USB Type-C ENGINEERING CHANGE NOTICE

Title: Rp Detect Timing

Applied to: USB Type-C Specification Release 1.2, March 25, 2016

(a). Section 4.5.2, Figure 4-14, Page 137

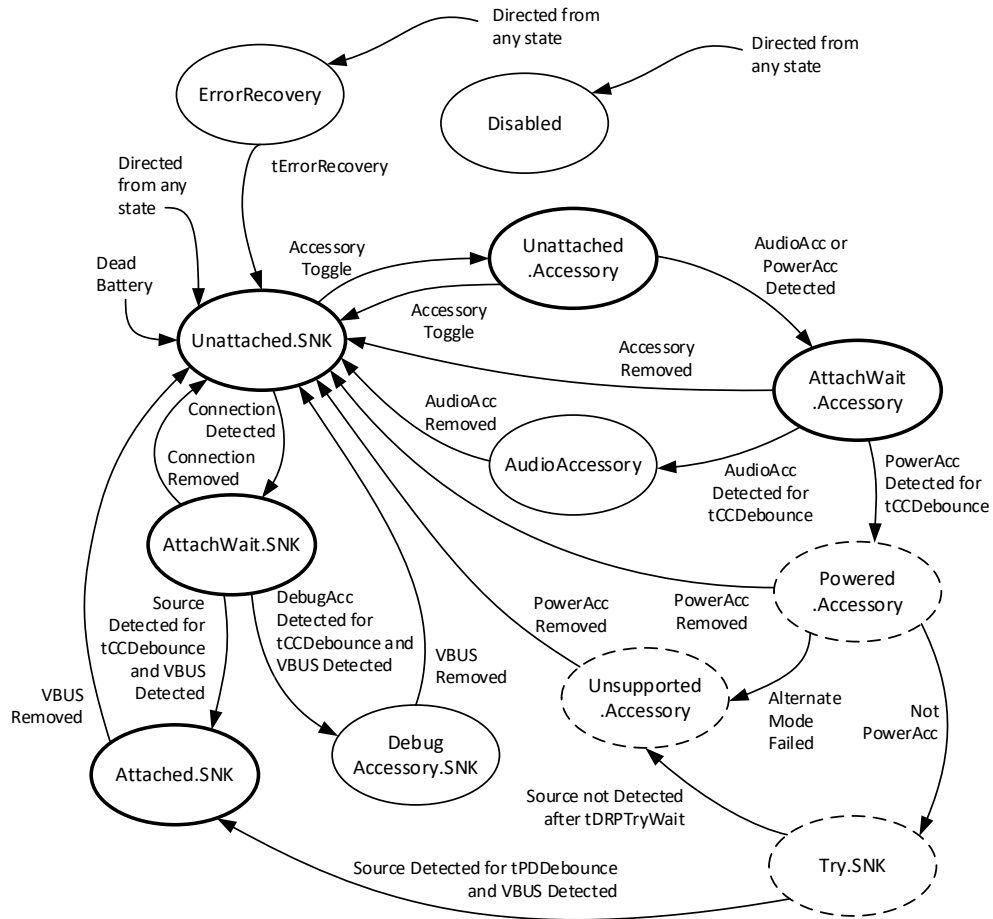
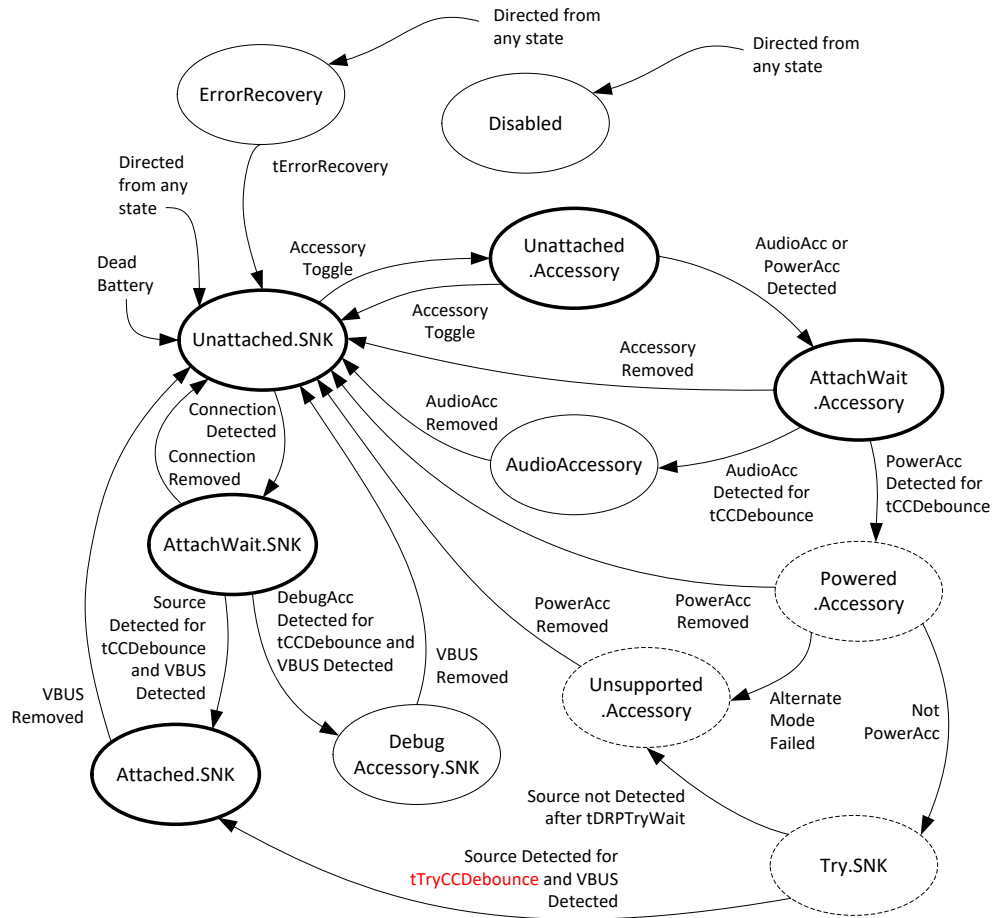
tPDDebounce is being over-loaded for several different purposes. It is being used to detect detach, also Rp current changes as well as Try attach time; tPDDebounce was intended only for detach with tCCDebounce being used for attach. This ECR separates the different functional usages and also clarifies the Rp change detect time in the absence of PD signaling for systems that can detect BMC idle.

Change in current timing detection.
